# CITY OF ROCHESTER HILLS OAKLAND COUNTY, MICHIGAN EASTERN AVENUE PARKING LOTS CITY FILE # - X00-000

Site Plan Review		
Reviewed for compliance to the City Ordinance, Building and Fire Codes		
Department	Reviewer	Approved
Planning	Kristen Kapelanski 248-841-2772 KapelanskiK@RochesterHills.org	Yes
Building	Mark Artinian 248-841-2446 ArtinianM@RochesterHills.org	Yes
Engineering	Jason Boughton 248-841-2490 BoughtonJ@RochesterHills.org	Yes
Traffic	Keith Depp 248-841-2503 DeppK@RochesterHills.org	Yes
Nat. Resources	Matt Einheuser 248-841-2551 EinheuserM@RochesterHills.org	Yes
Fire	Lt. Josh Boyce 248-841-2713 BoyceJ@RochesterHills.org	Yes
<b>City of Rochester Hills</b> <b>Planning &amp; Economic Development</b> Conditions and mark-ups noted throughout the plan set must be addressed prior to final approval.

CONTRACT FOR: CONSTRUCTION OF PARKING LOTS AND WALKWAY ALONG EASTERN AVENUE FROM CITY PROPERTIES SOUTH OF THE SOUTH DOWNTOWN ALLEY TO AUBURN ROAD.

CITY OF ROCHESTER HILLS  
EASTERN AVENUE PARKING LOTS  
LANDSCAPE PLANTING PLAN

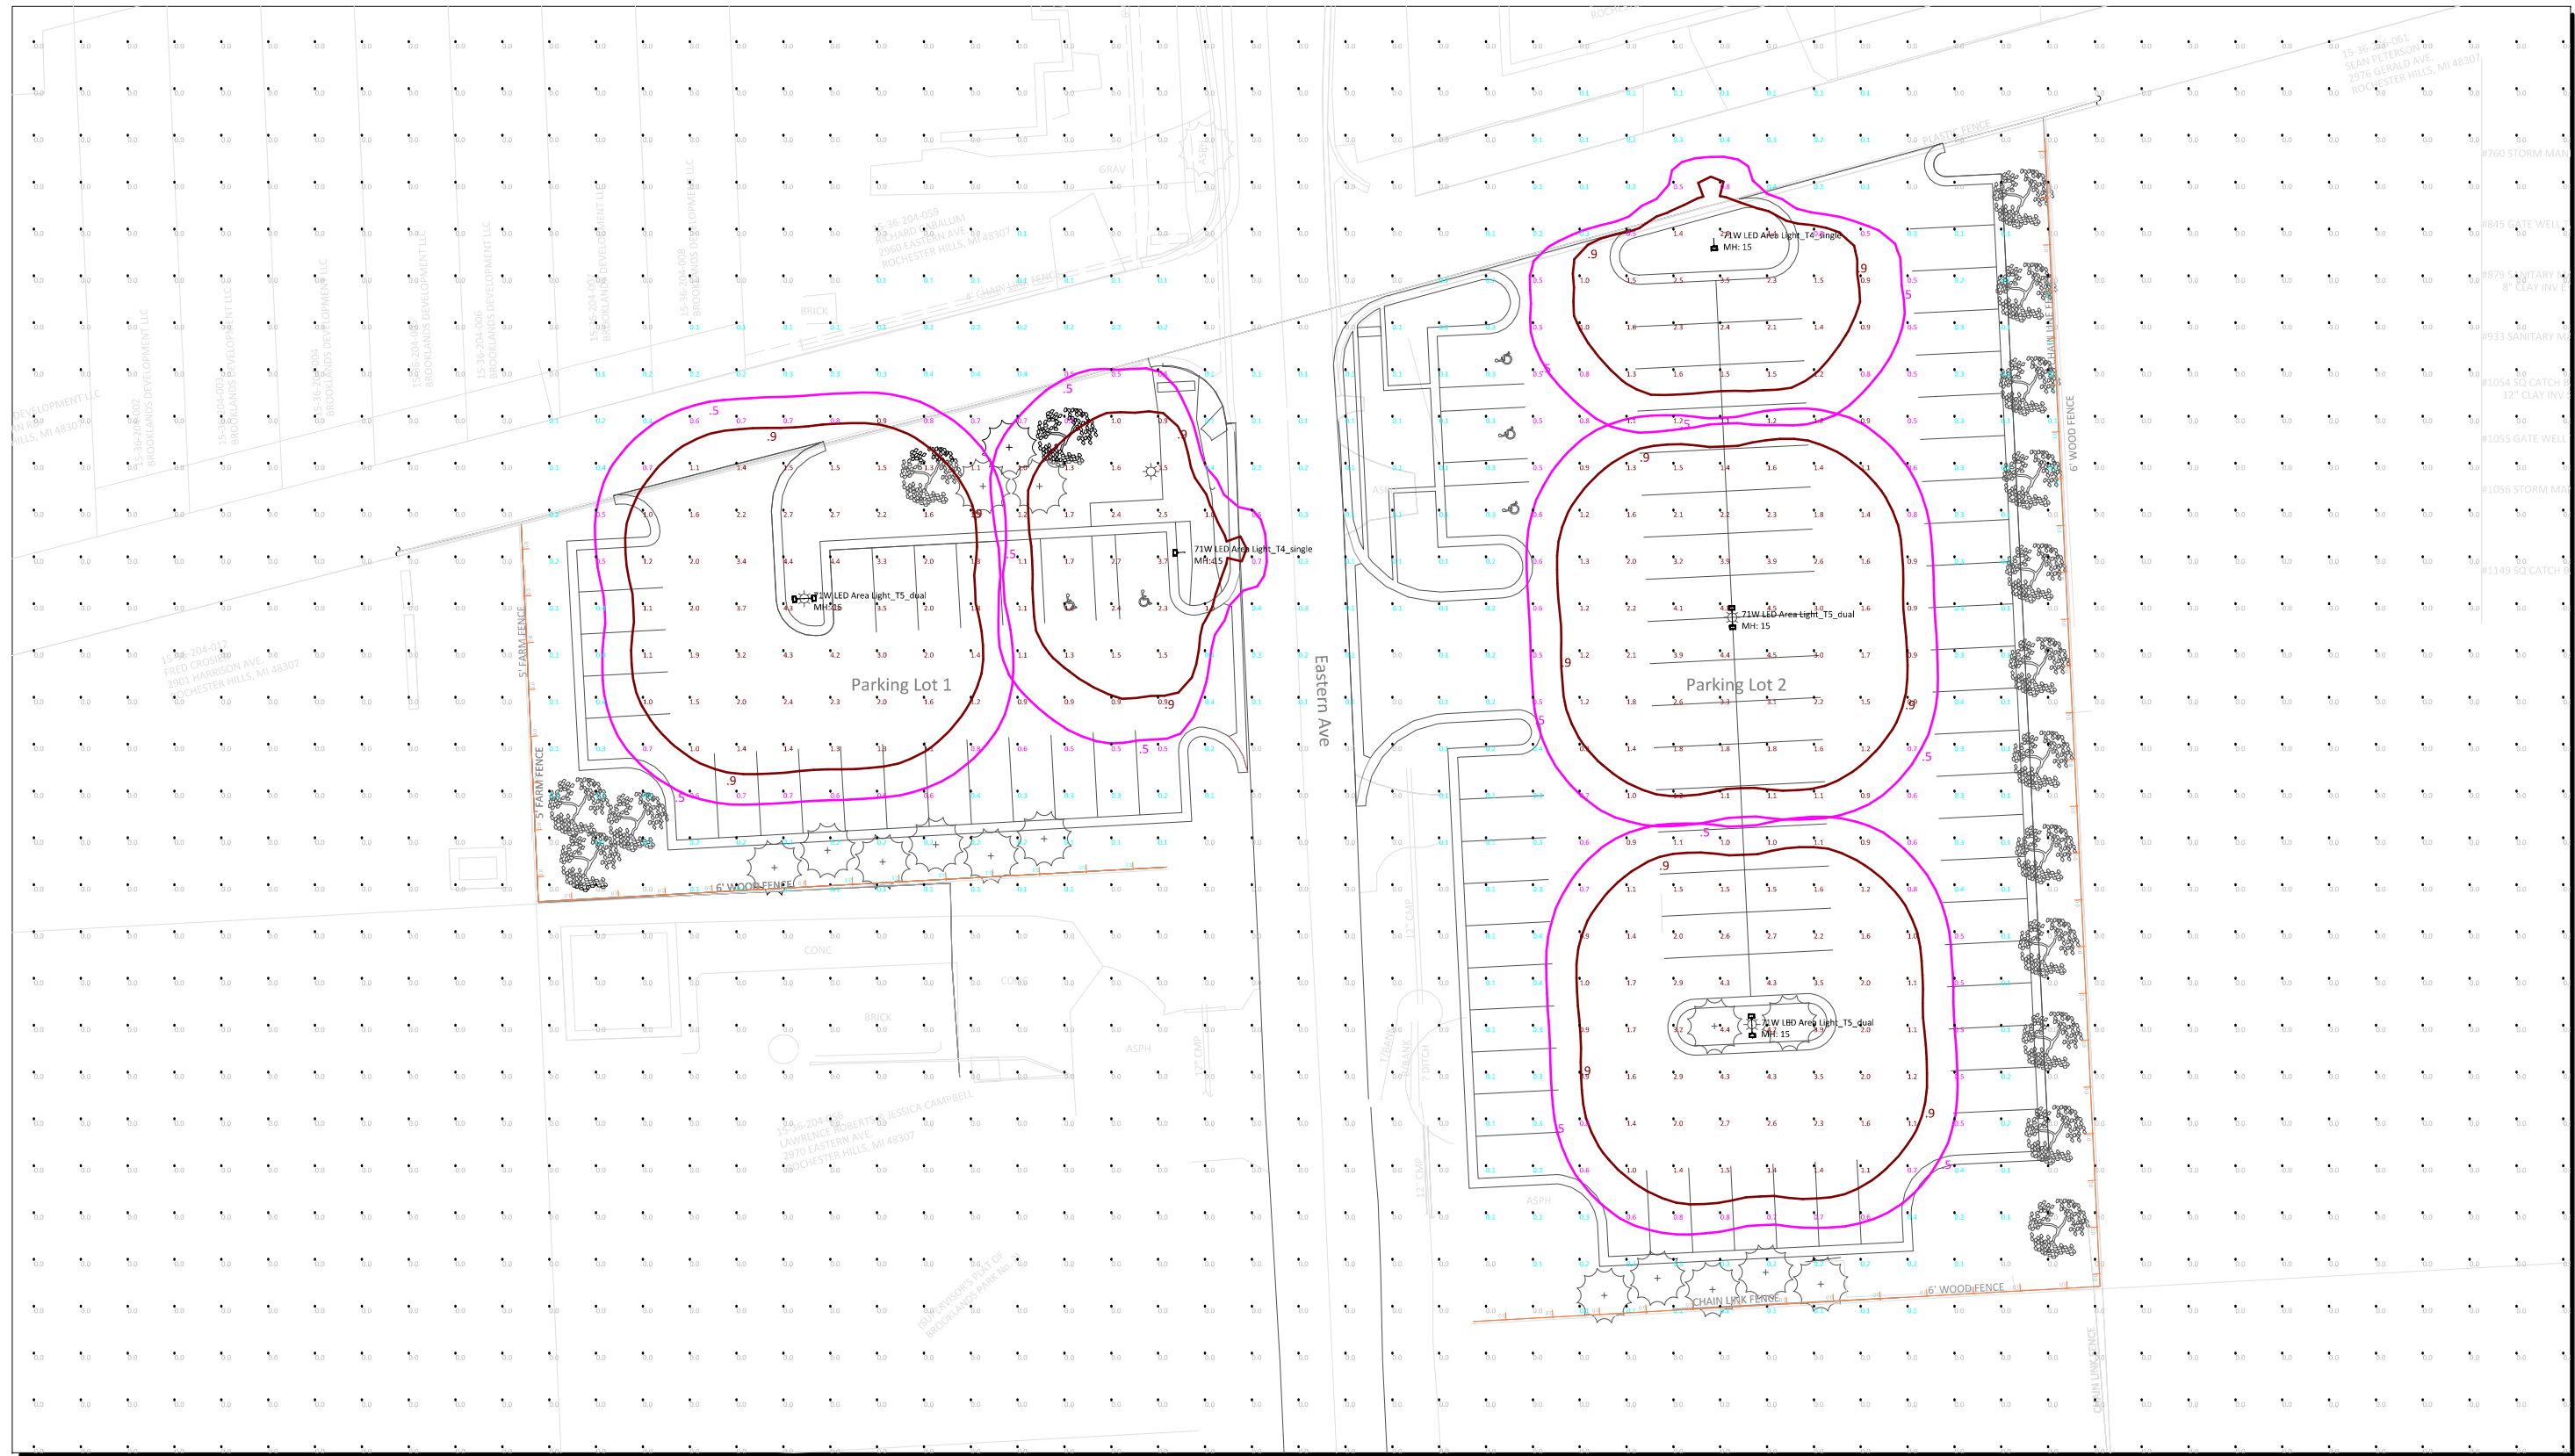
Note on Landscape Plans Irrigation overspray shall not broadcast onto City pathway.
